WRA EXHIBIT 1

Post-IRP Draft Errata, Refinements, and
Corrections

2025 Integrated Resource Plan Public Input Meeting January 22-23, 2025

Errata to the IRP Document

Figure 6.7 – West Summer Capacity Position Trend

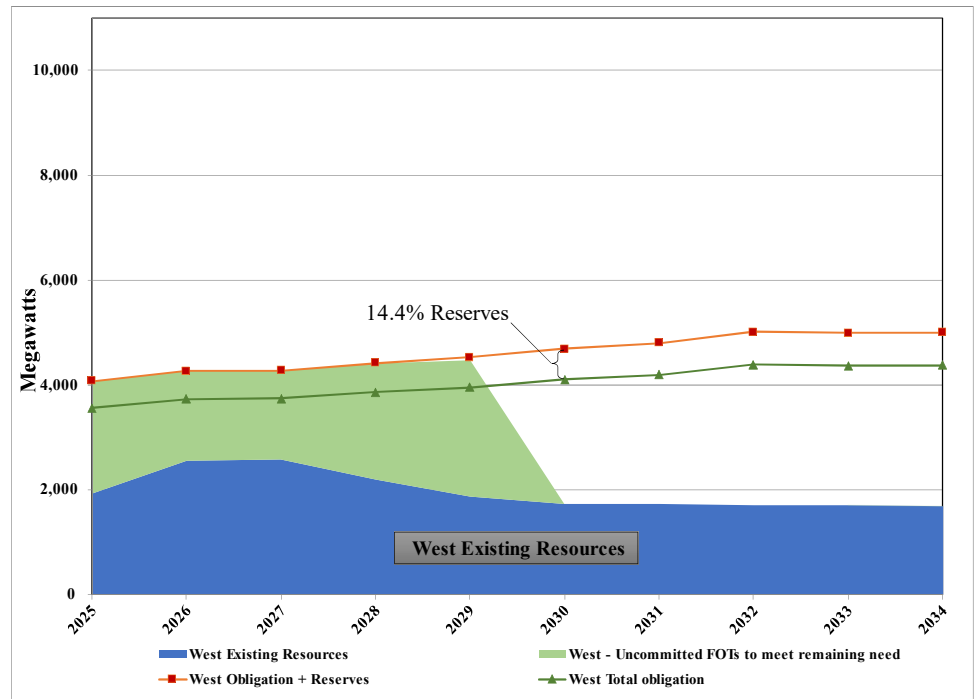
- Chapter 6, Figure 6.6 – East Summer Capacity Position Trend was pasted in for Chapter 6, Figure 6.7 – West Summer Capacity Position Trend. The corrected Figure 6.7 is displayed on the right.
